# MEADOWBROOK PARK

## PLANNED UNIT DEVELOPMENT (PUD) AND PRELIMINARY PLAN

# PUD V\_2 review 2 planning only.pdf Markup Summary 4-30-2021

MEADOWBROOK PARK  
PLANNED UNIT DEVELOPMENT (PUD) PLAN

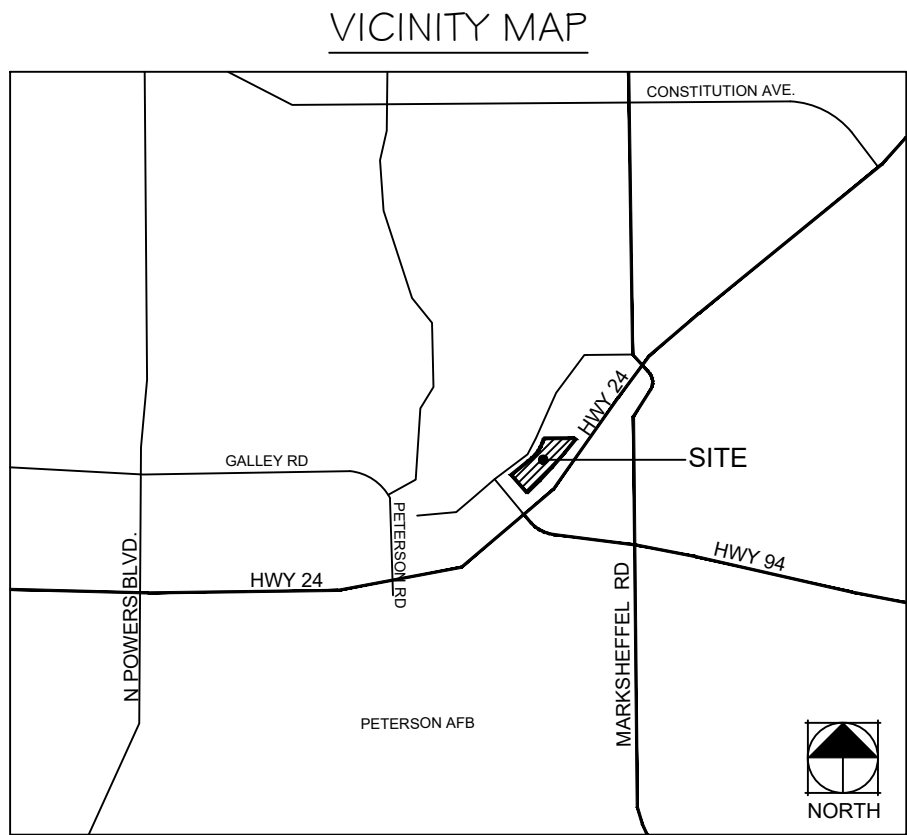
Add the mitigation techniques such a the perimeter drains to these notes. See CGS comments and the revised Geo reprot after revisions.

high ground water.....under drains etc..address this in GEO report and add notes for the specific lots impacted. who is to maintain under drains? The District. Are some lots not eligible for basements? which ones?

MEADOWBROOK PARK  
PLANNED UNIT DEVELOPMENT (PUD) PLAN

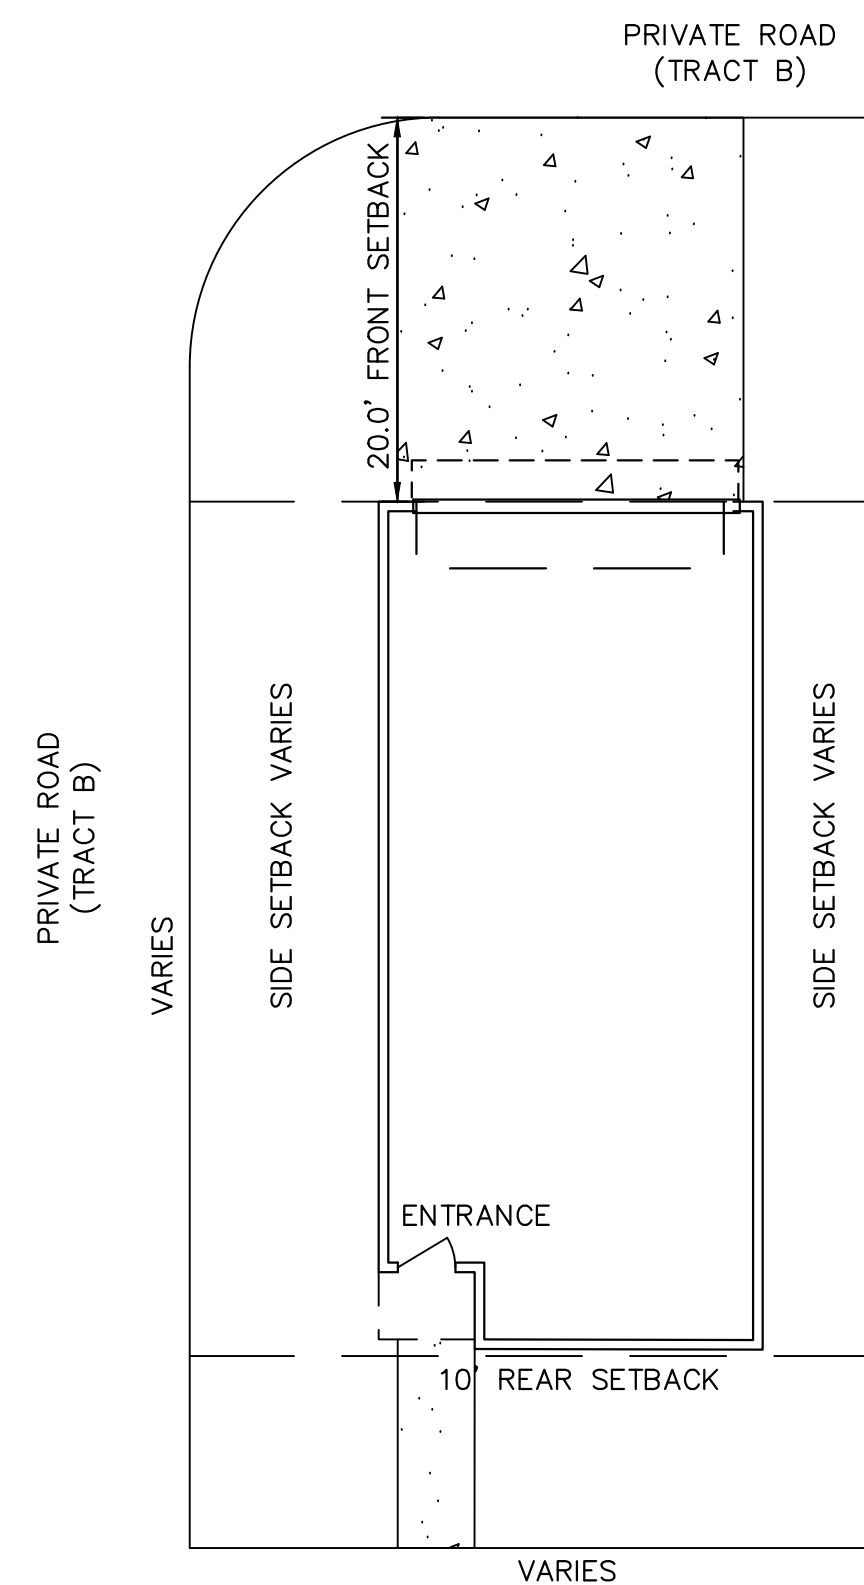
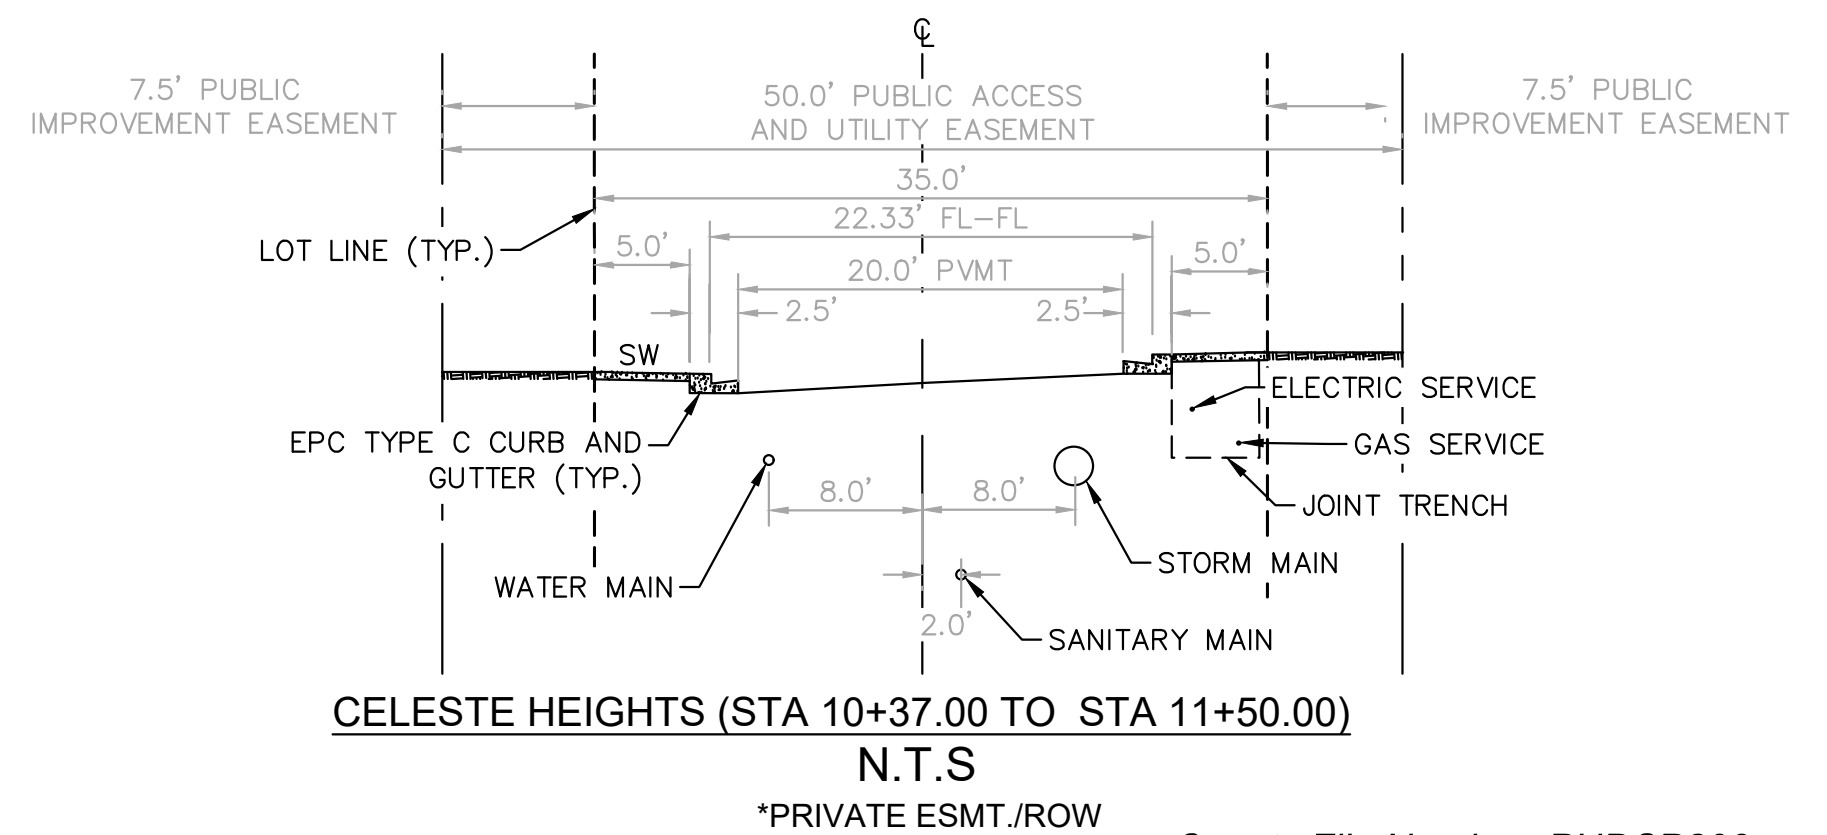
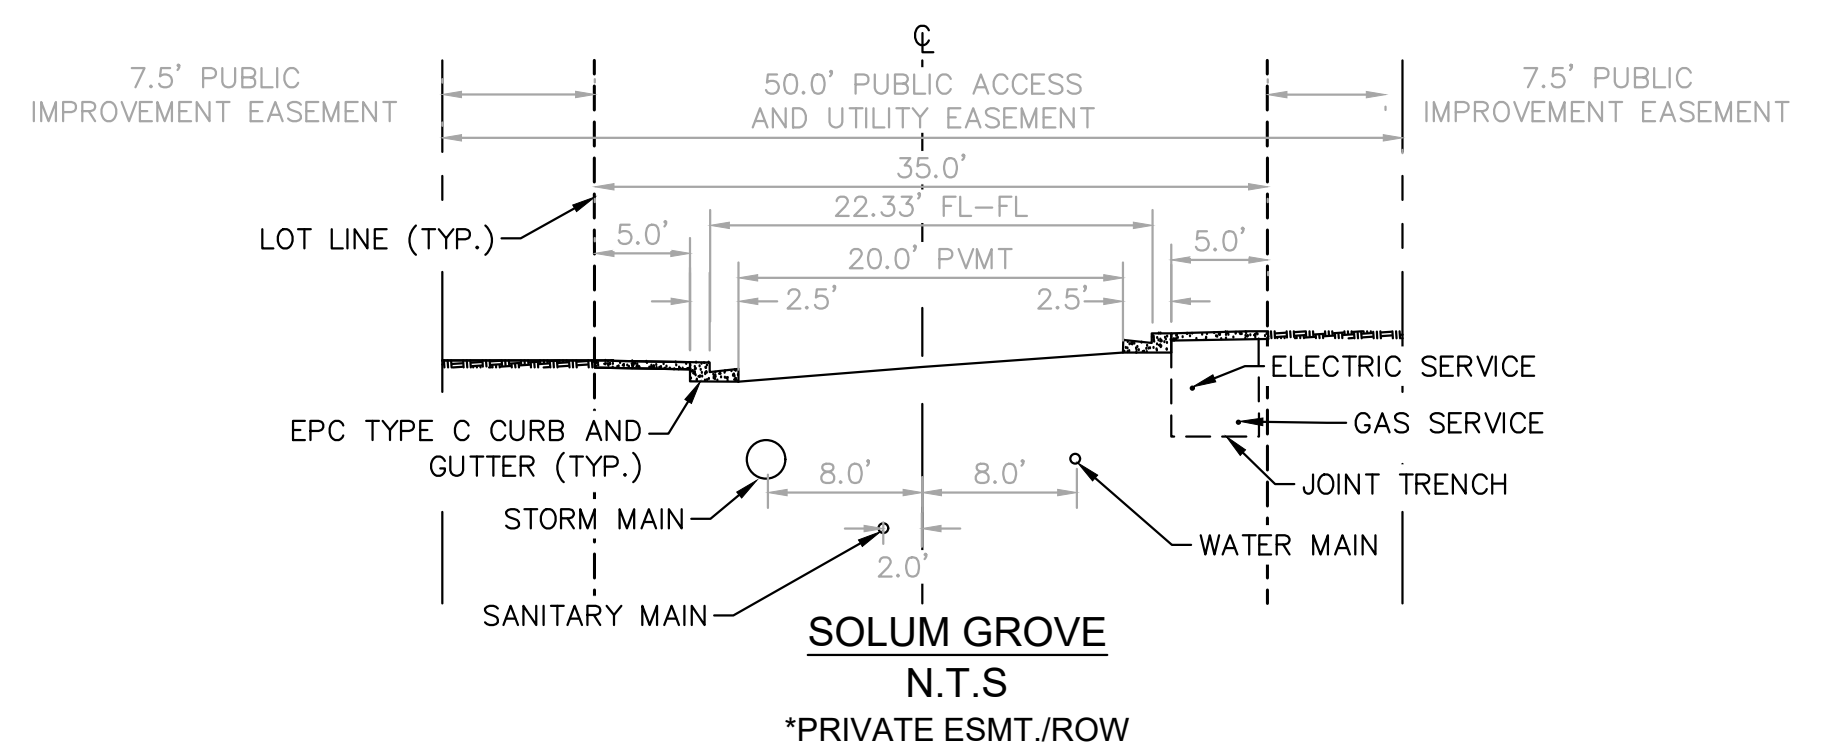
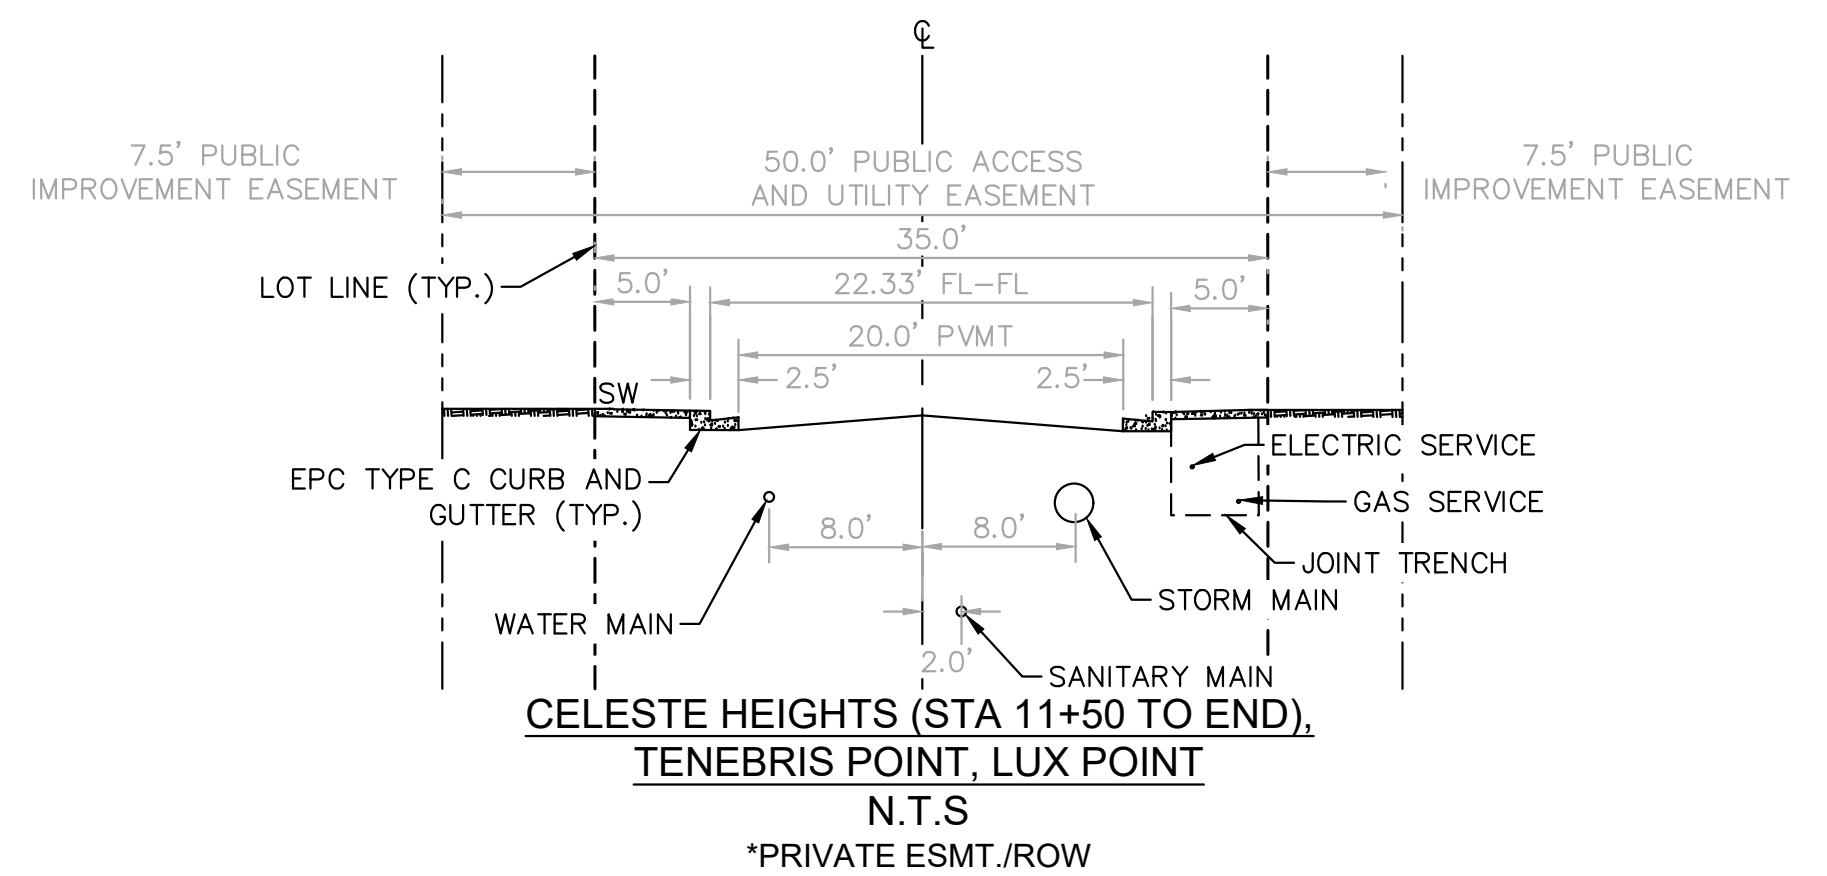
you noted no accessory structures so clarify if they can have a covered porch or pergola on details and a rear deck

**RETAINING WALL WALL DETAIL**

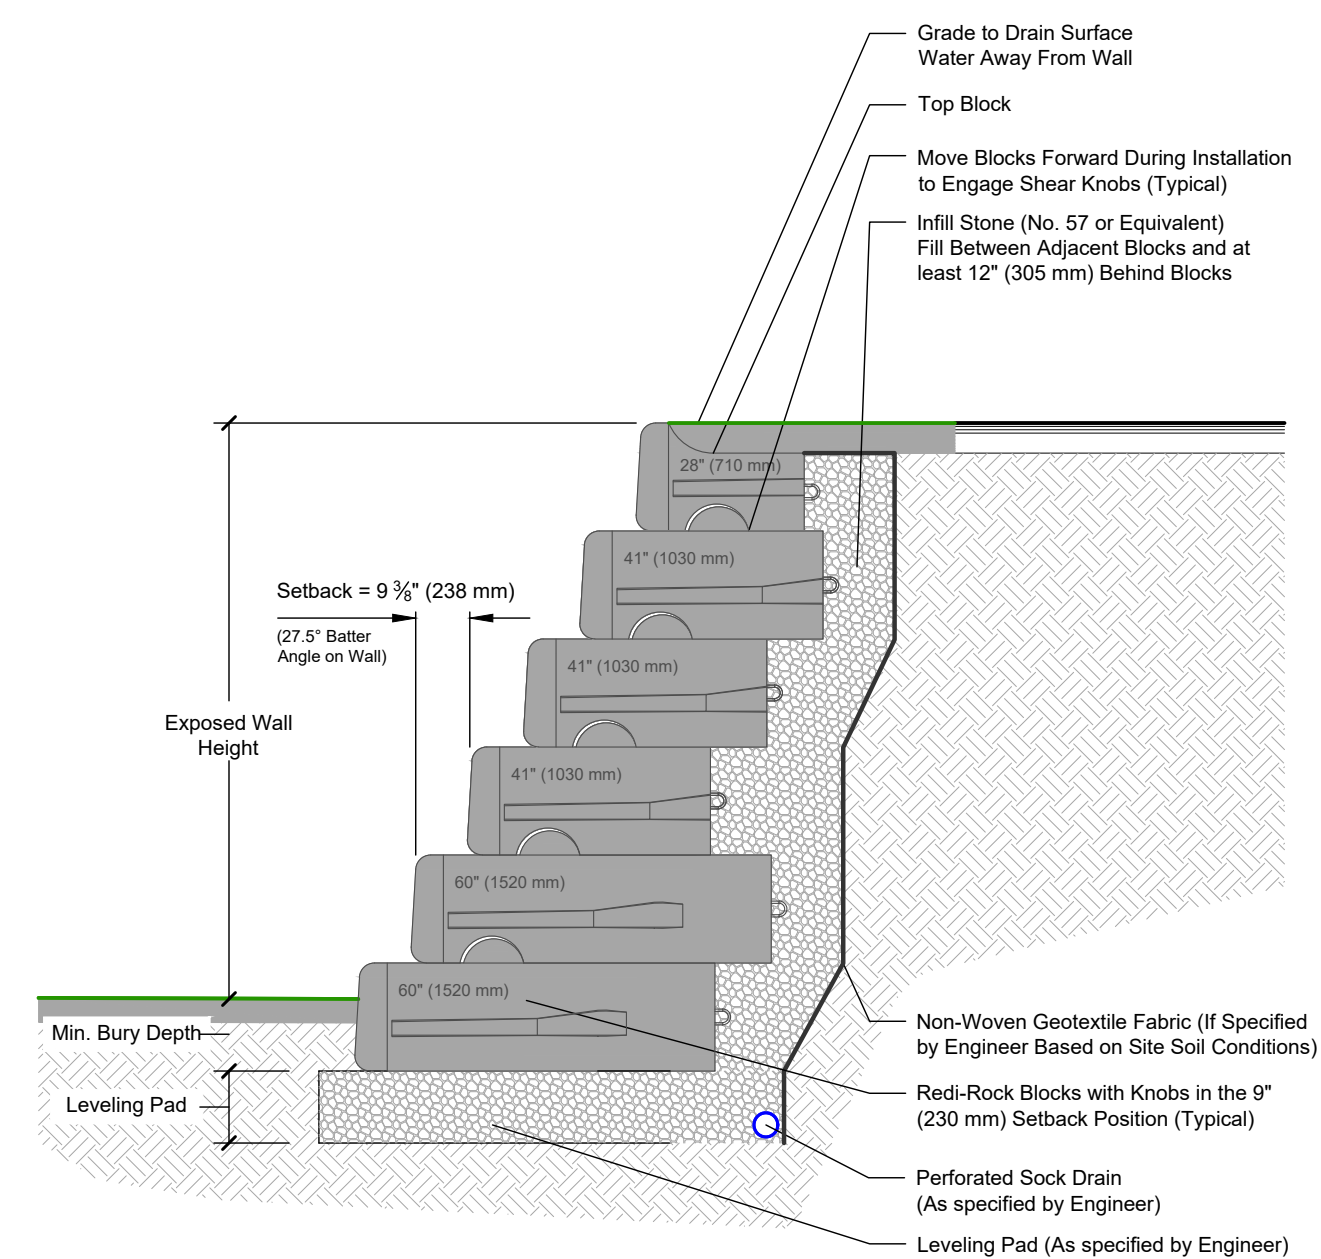
is this noise wall as noted on sheet 1 along Meadowbrook Parkway?
